Sheet No. C0.0

Project Title:
EAST TOWN CROSSING PHASE 1

Project No.
2230752
Issue Set & Date:
PERMIT SUBMITTAL
11/20/2023

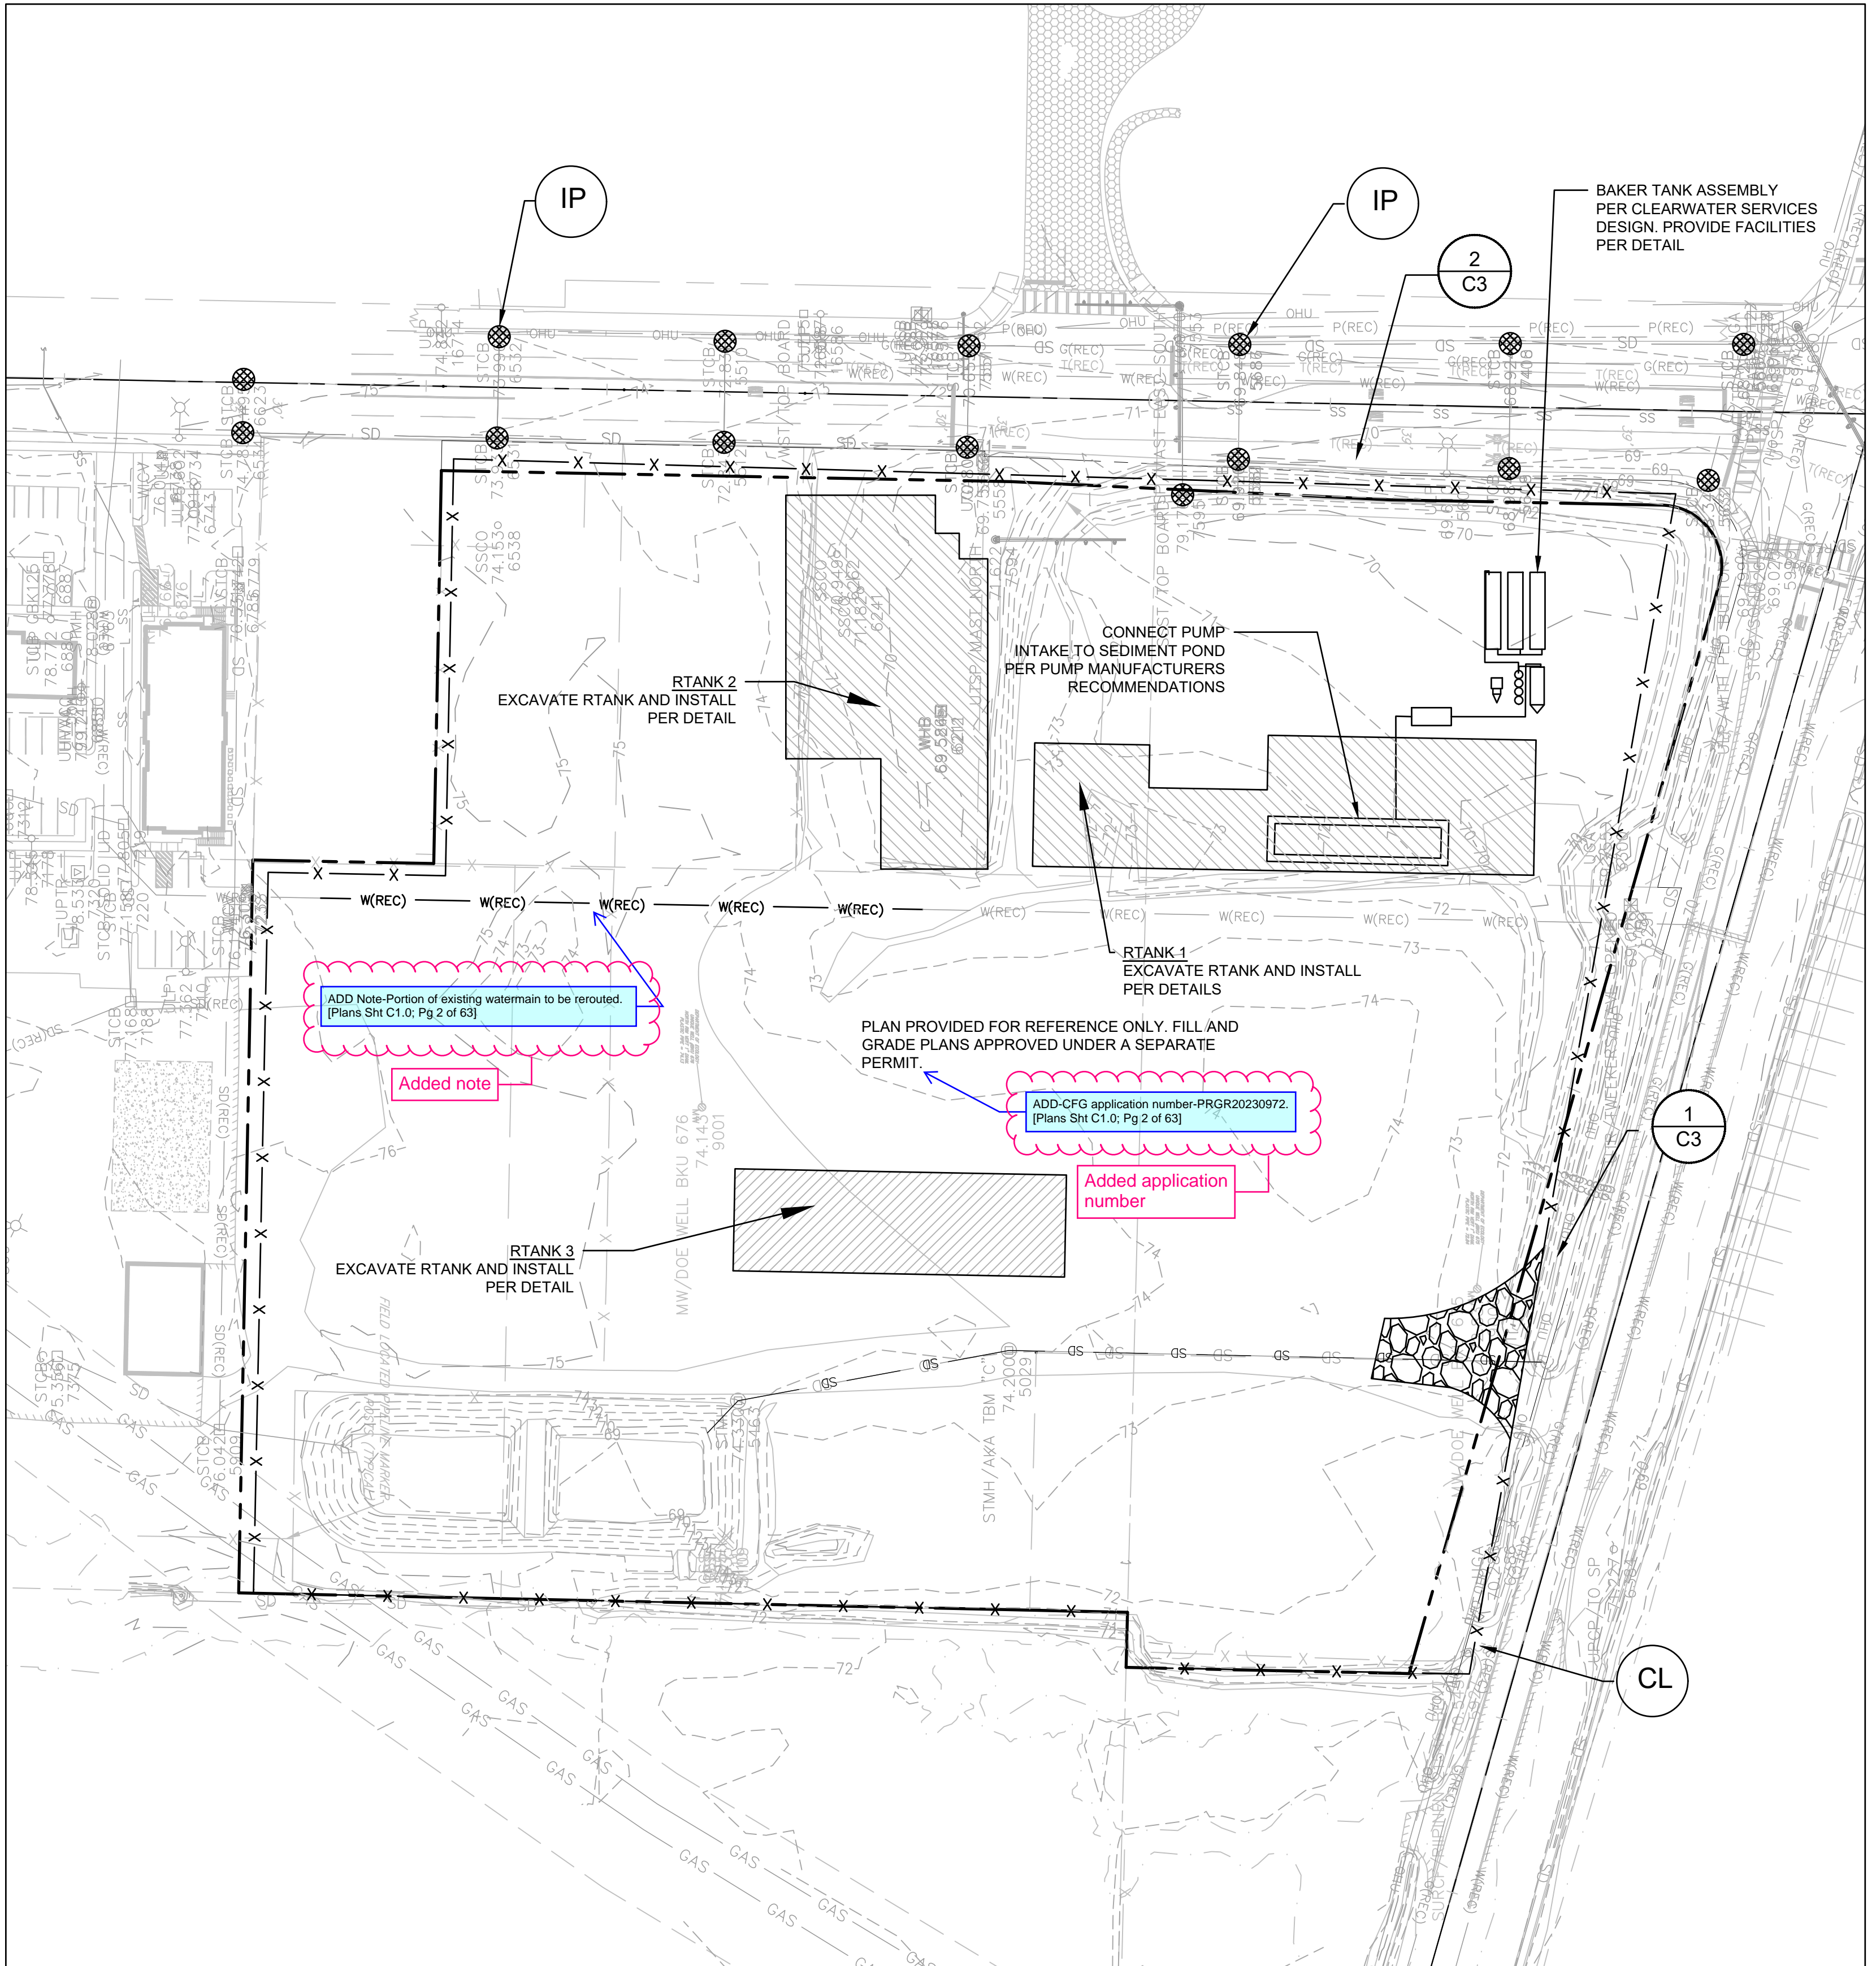
ADD CFG application number-PRGR20230972. [Plans Sht C1.0; Pg 2 of 63]

ADD Note-Portion of existing watermain to be rerouted. [Plans Sht C1.0; Pg 2 of 63]

3 INLET PROTECTION SCALE: NTS

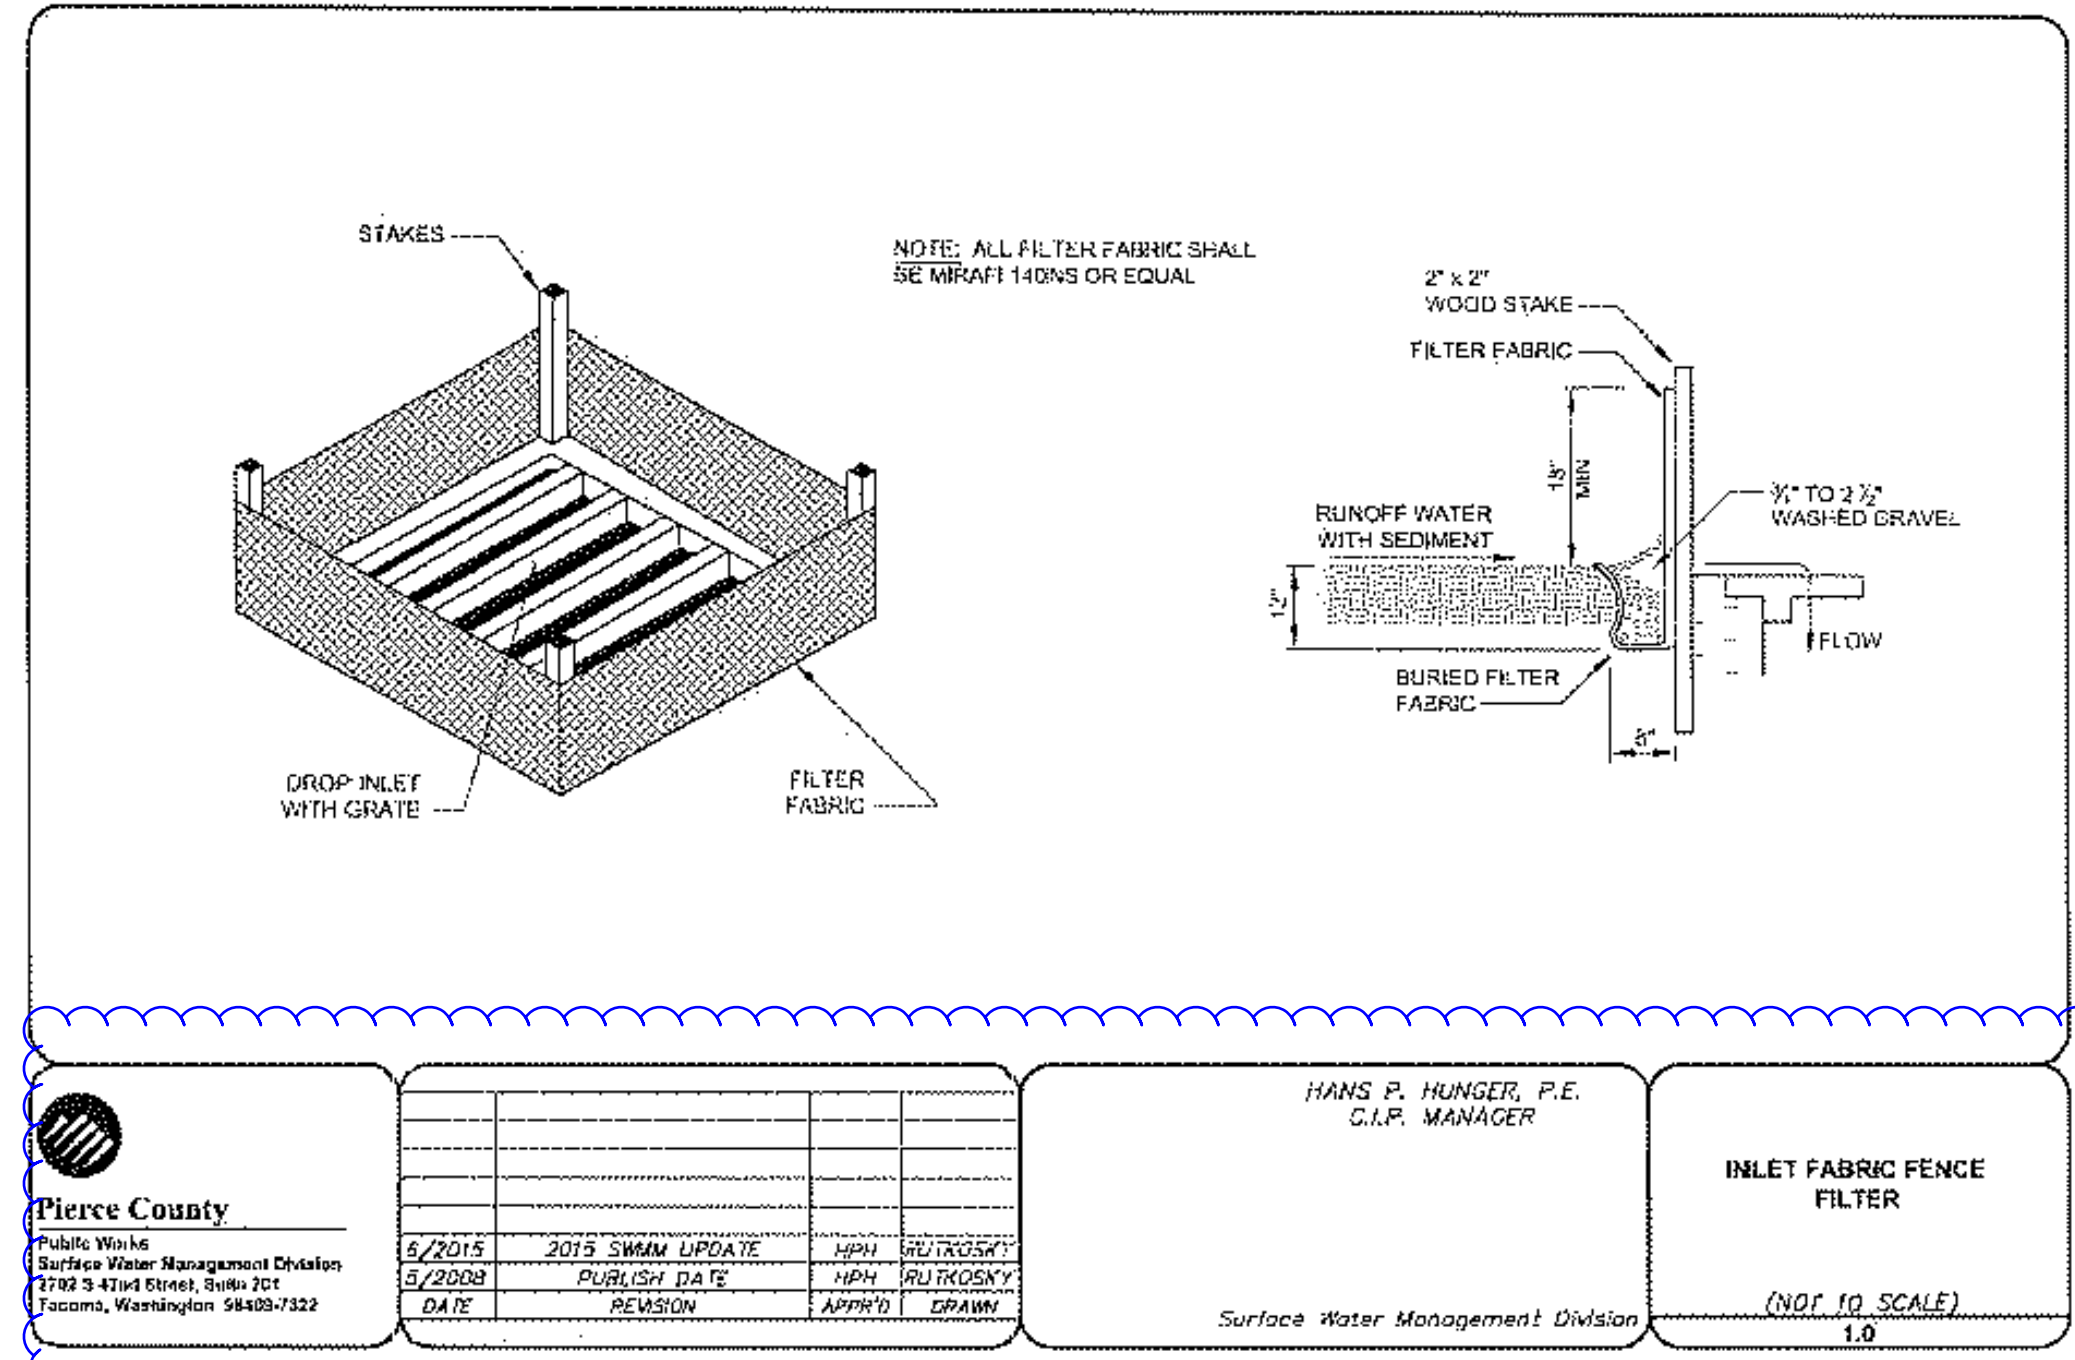
OK to use detail...please remove title block info [Plans Sht C1.1; Pg 3 of 63]

Sheet No.
C2.4

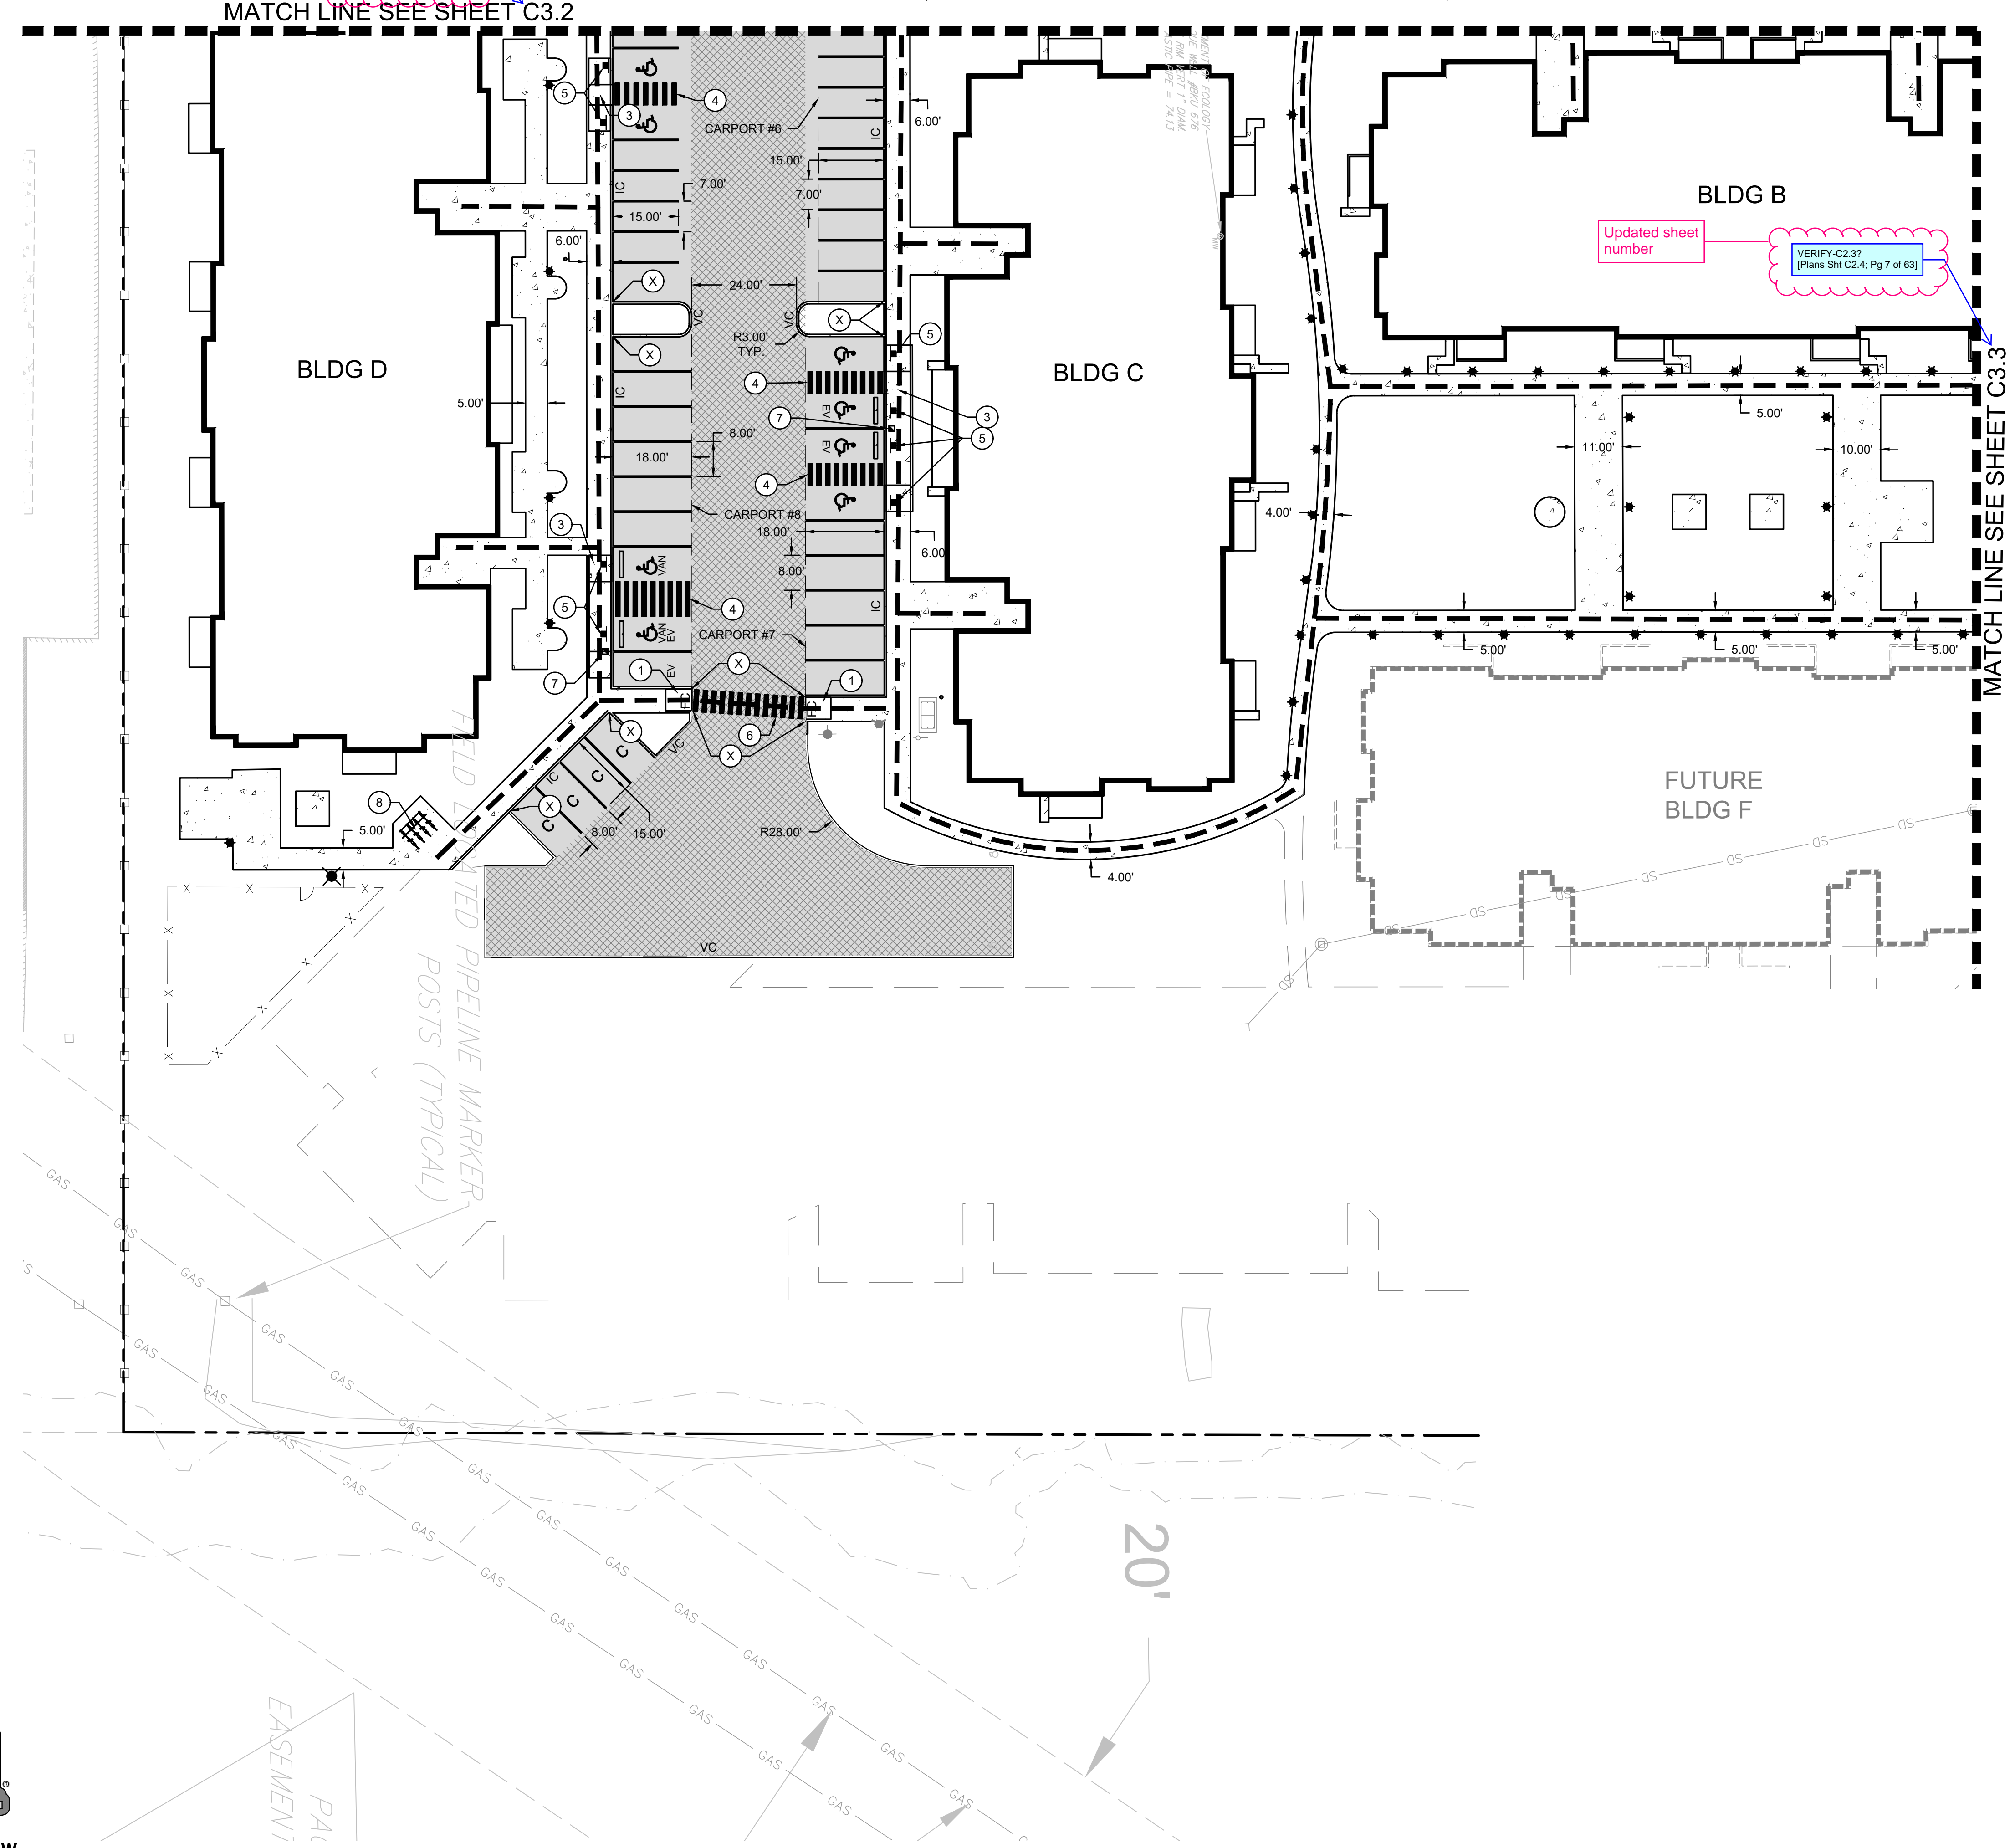
Updated sheet number
VERIFY-C2.2?
(Plans Sht C2.4, Pg 7 of 63)

Updated sheet number
VERIFY-C2.3?
(Plans Sht C2.4, Pg 7 of 63)
